Layout Name
21-05495 McEntire Blueprint

Ground Floor

- ☒ Conforms to Design Concept
☐ Conforms to Design Concept with Revisions Noted
☐ Non-Conforming; Revise and Resubmit

Layout Name
21-05495 McEntire Blueprint

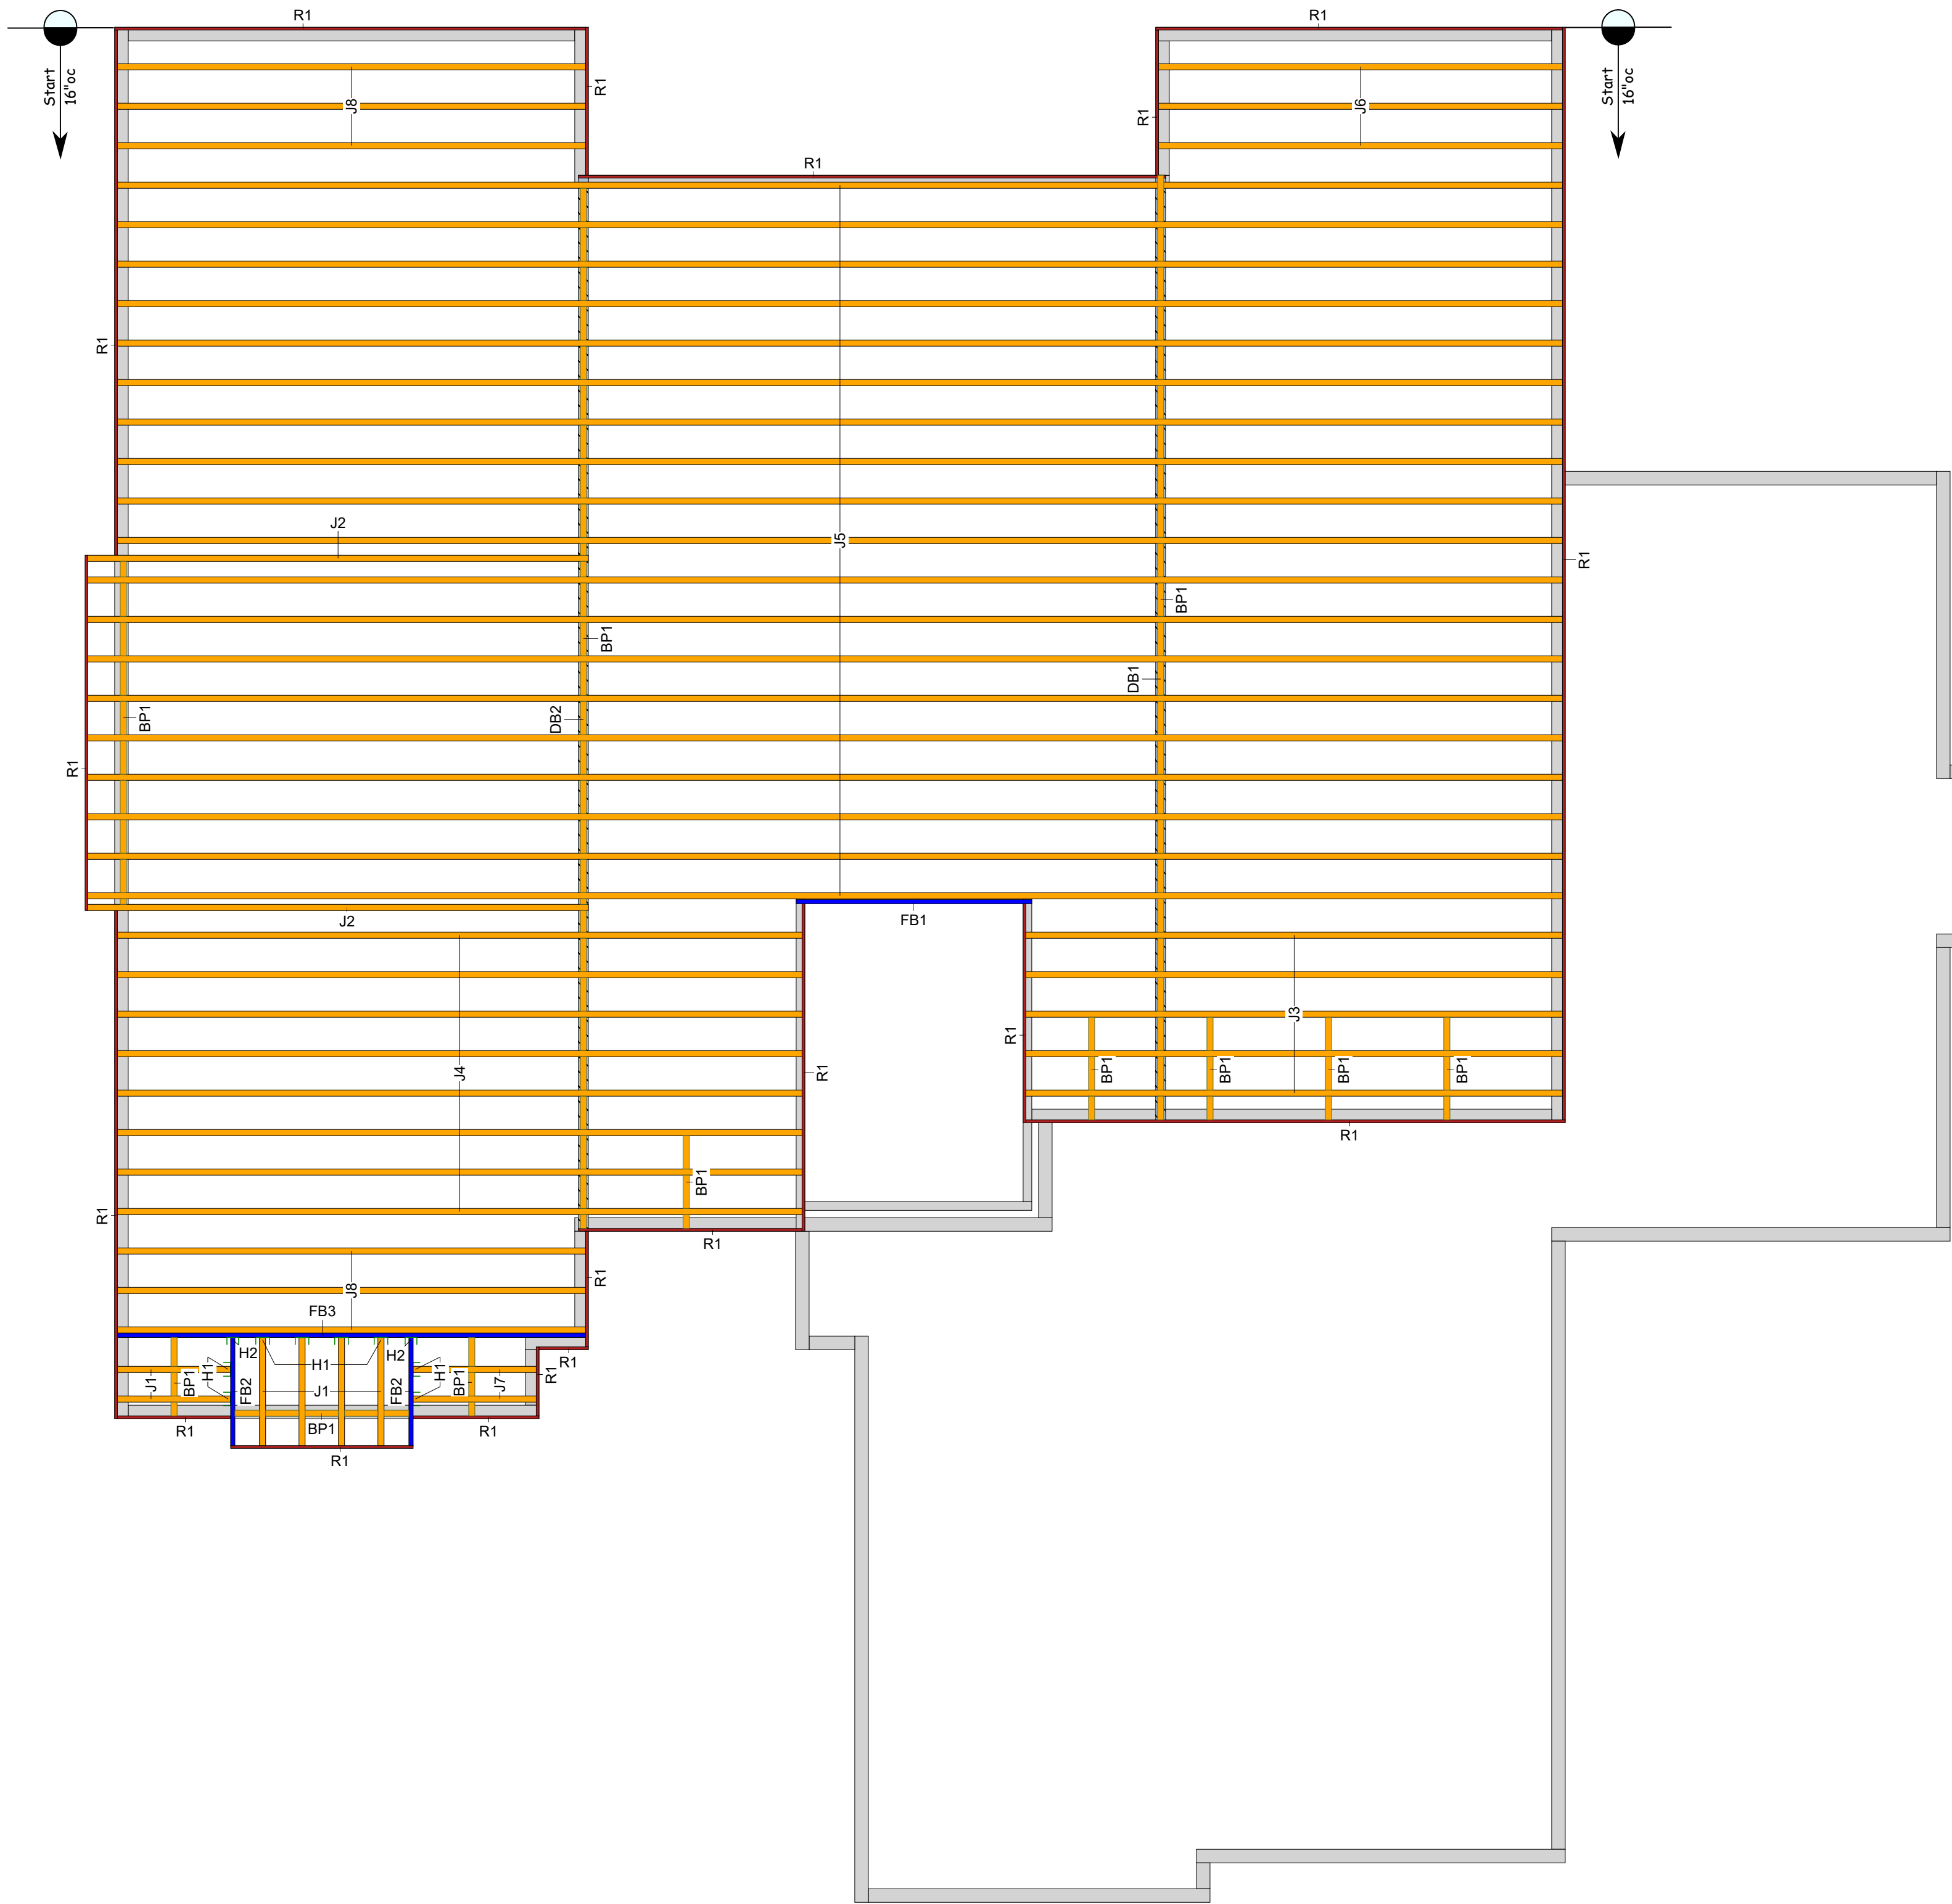
THIS SHOP DRAWING HAS BEEN REVIEWED FOR GENERAL CONFORMANCE WITH DESIGN CONCEPT ONLY AND DOES NOT RELIEVE THE FABRICATOR, VENDOR, OR ORIGINAL DESIGN ENGINEER OF RESPONSIBILITY FOR CONFORMANCE WITH DESIGN DRAWINGS, SPECIFICATIONS, AND APPLICABLE CODES, ALL OF WHICH HAVE PRIORITY OVER THIS SHOP DRAWING.
